MONITORING YEAR 2 ANNUAL REPORT

ALEXANDER FARM MITIGATION SITE

RE: Draft Year 2 Monitoring Report
Alexander Farm Mitigation Site, Alexander County
Yadkin River CU 03040101
DMS Project ID No. 100022 / DEQ Contract #007186

Wildlands Engineering, Inc. (Wildlands) has reviewed the Division of Mitigation Services (DMS) comments from the Draft Year 2 Monitoring Report for the Alexander Farm Mitigation Site. The report has been updated to reflect those comments. The Final MY2 Report is included. DMS' comments are listed below in **bold**. Wildlands' responses to DMS' comments are noted in *italics*. Comments received via email on January 4, 2022 are also included.

Figure 3.0 – 3.3 Current Condition Plan View

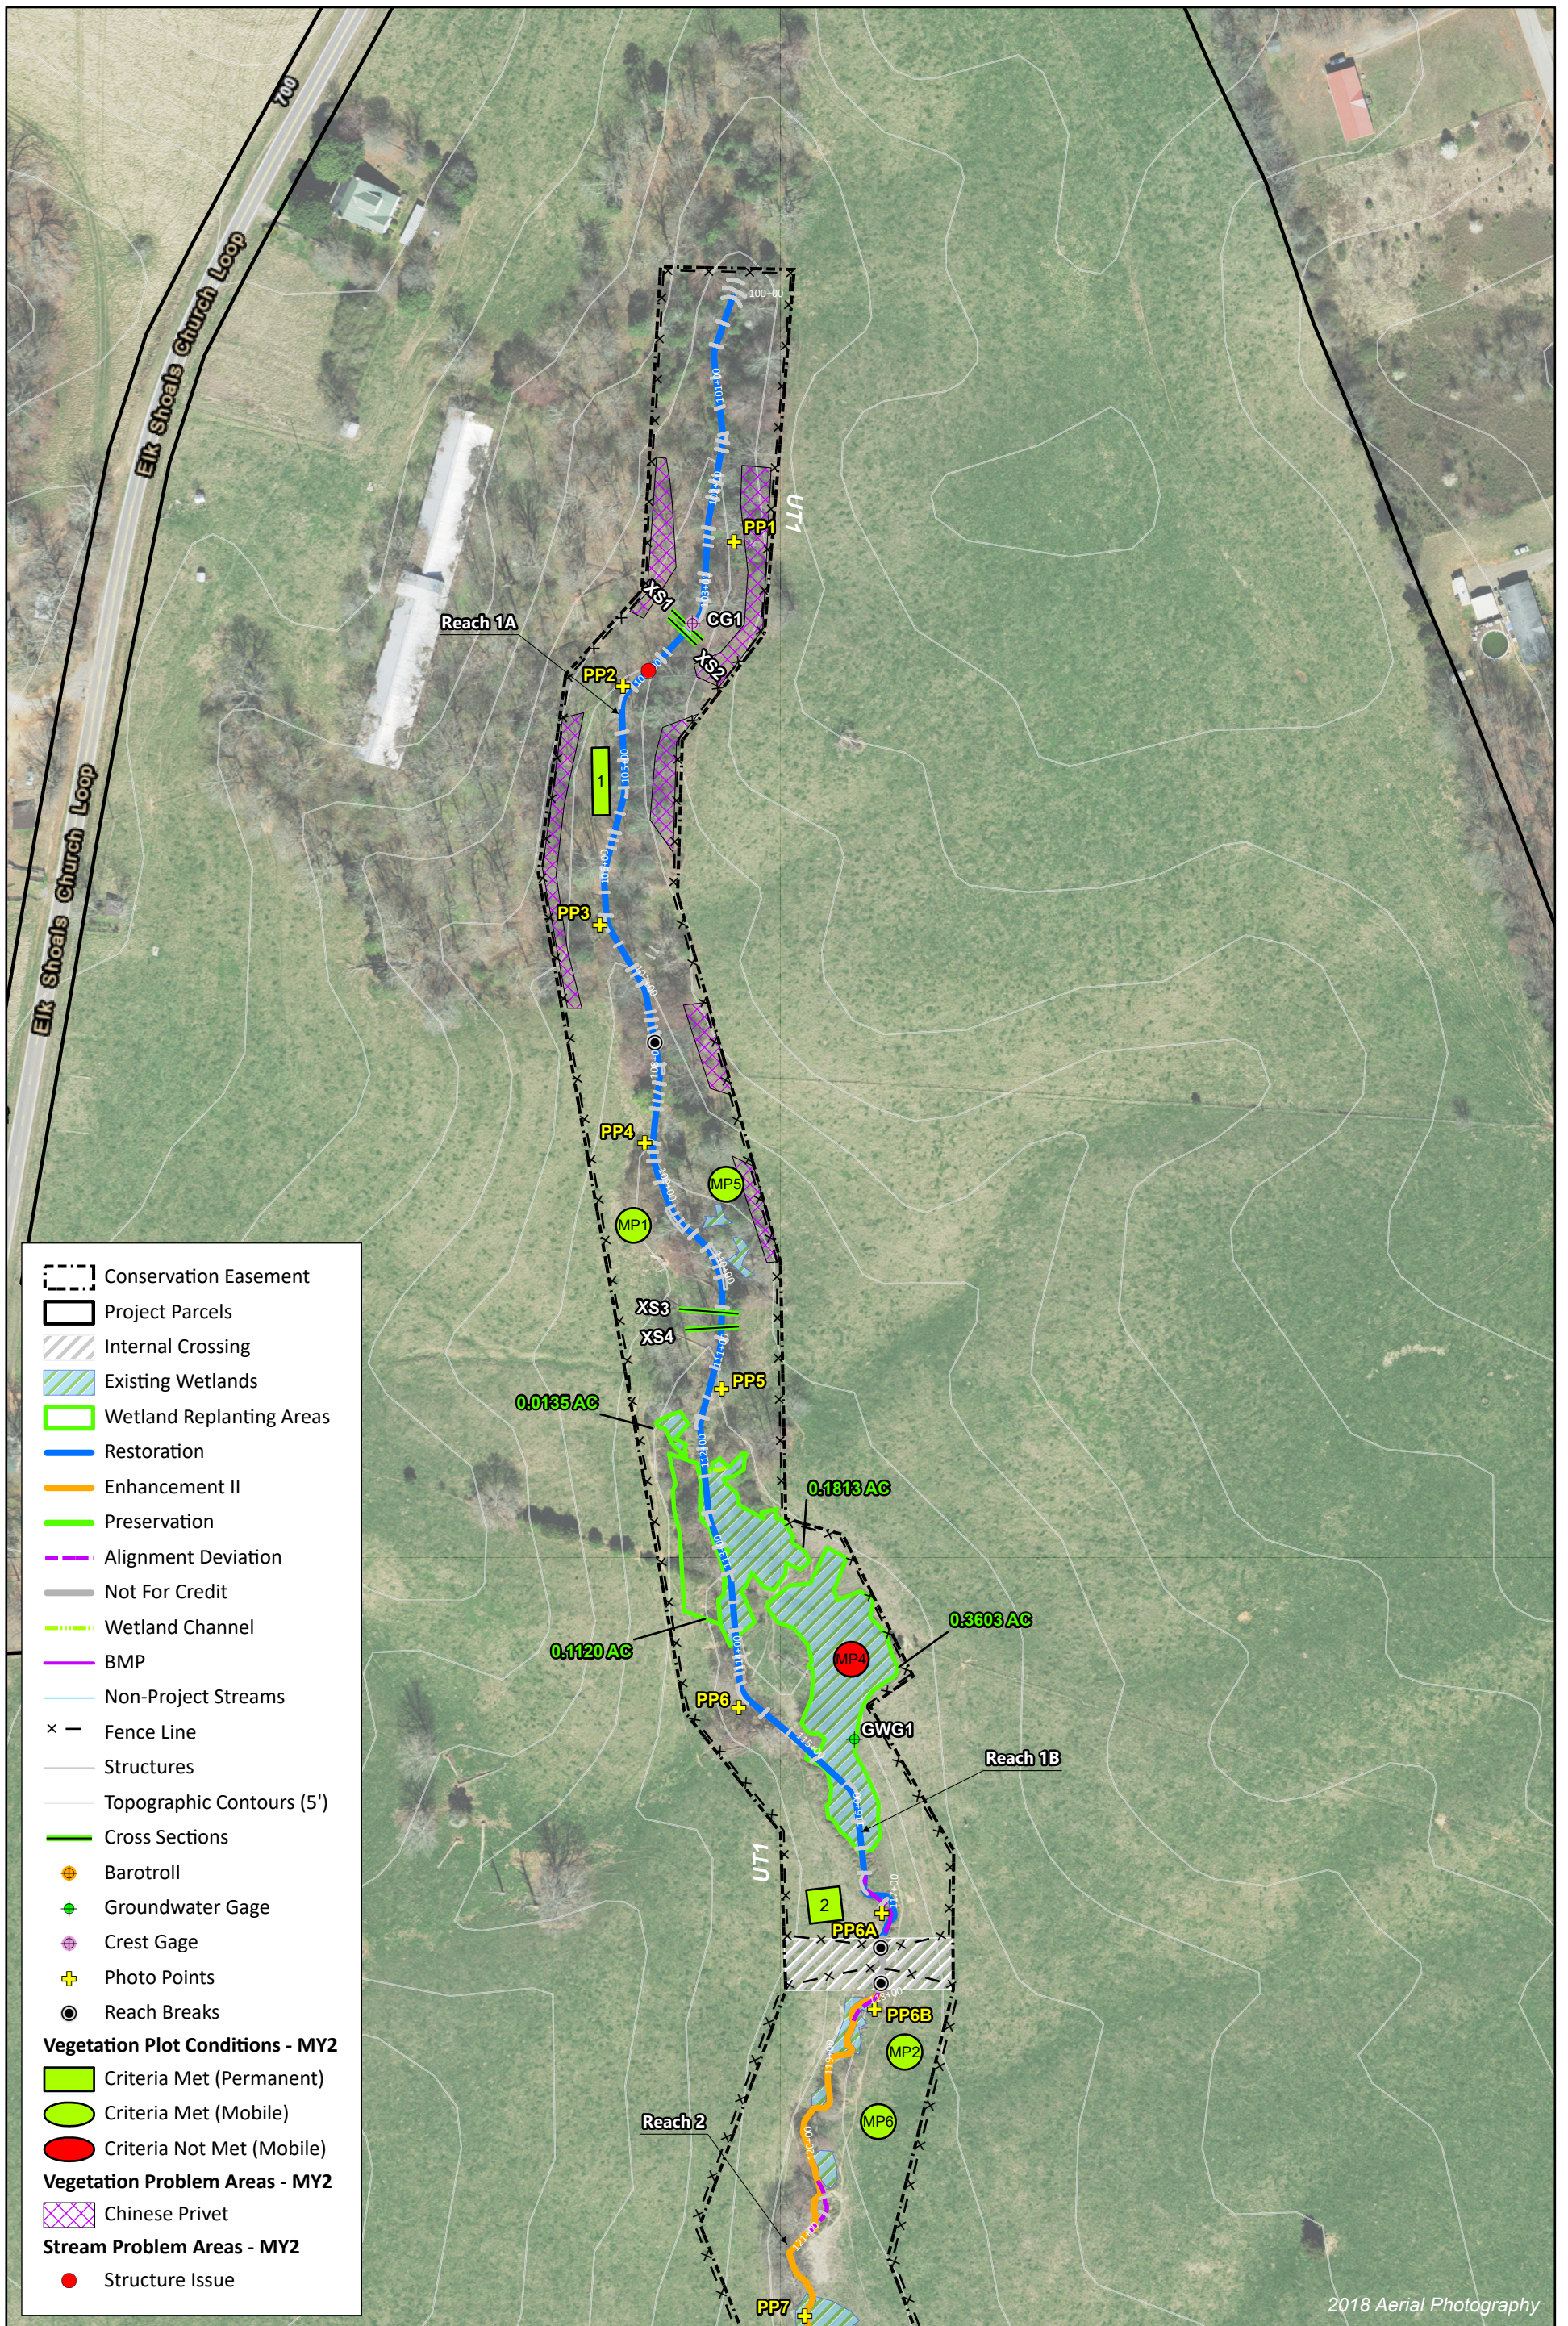
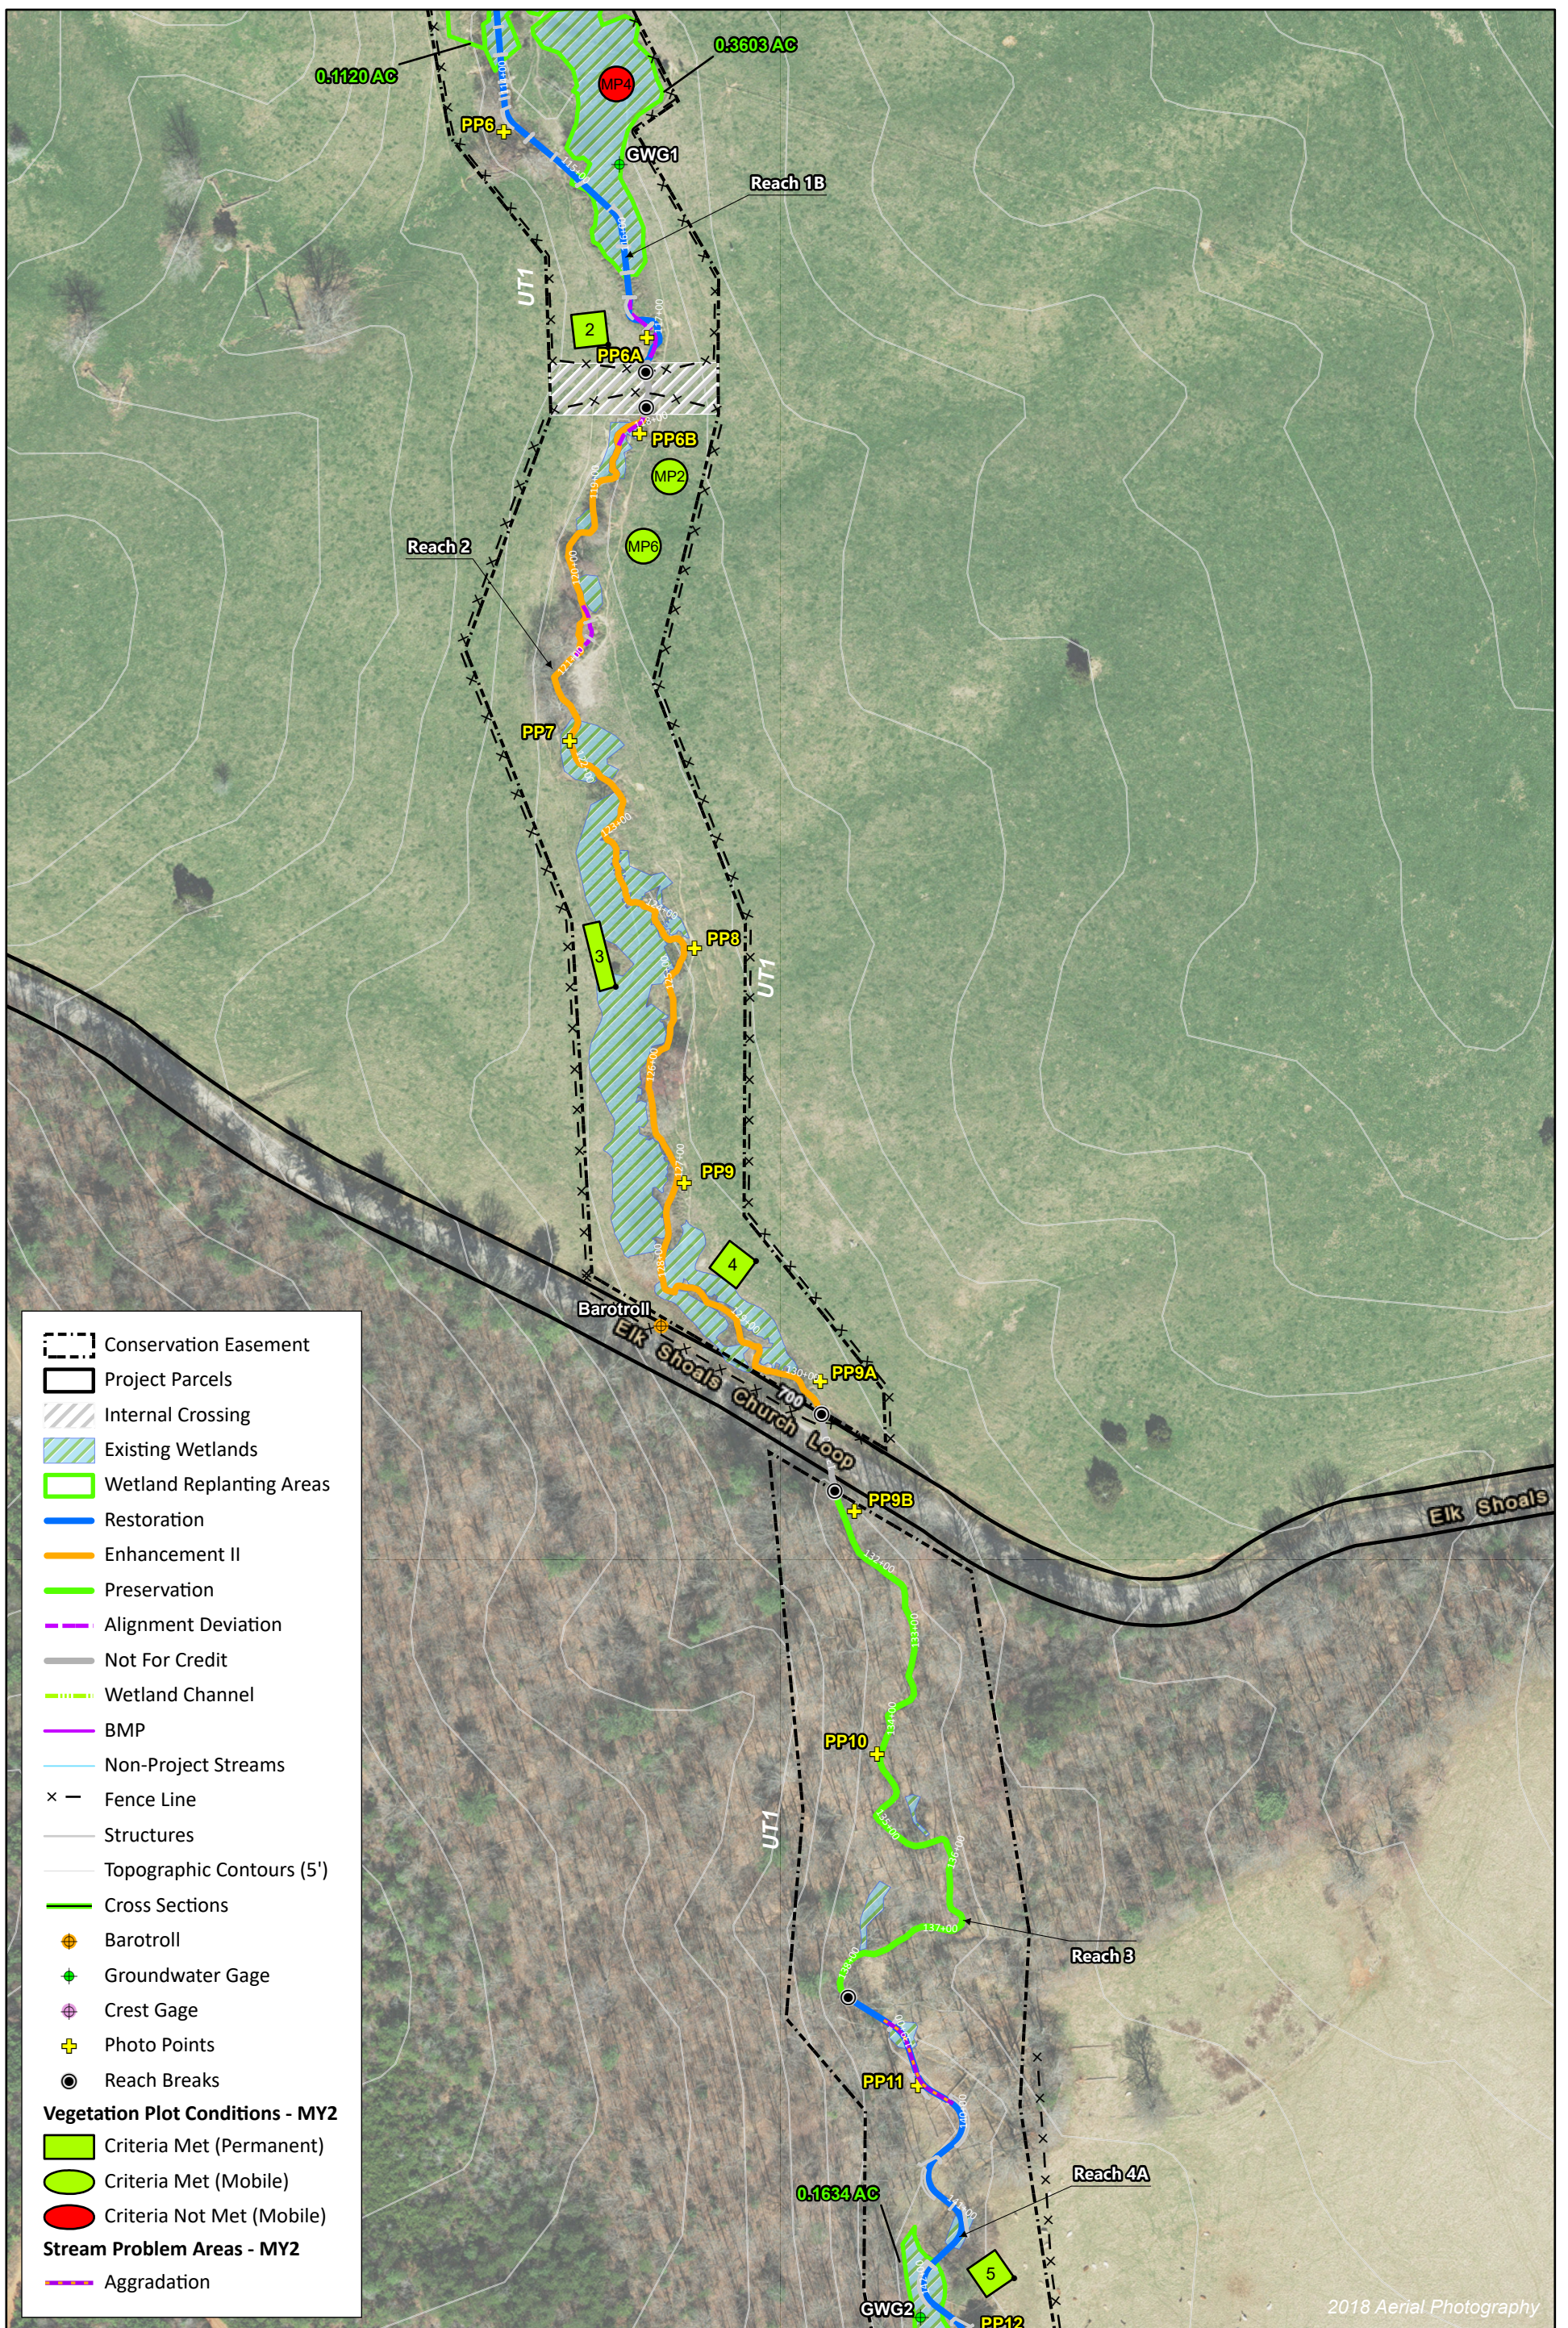
DMS' comment: There is a "bankfull" line on the CCPVs (thick dashed line), it is recommended removing this unless it serves a specific monitoring function on the maps.

DMS' comment: What is meant by "alignment deviation" on the CCPVs? Does this mean there has been significant lateral migration of the channel? If there is an issue with this it should be identified appropriately and discussed in the report in addition to being mapped.

Wildlands' response: Wildlands has removed the "bankfull" line from the CCPVs.

Wildlands' response: There is no issue with the channel in this area. The alignment deviation that is shown on the CCPV maps represents the as-built channel alignment and how it differs from the design alignment.
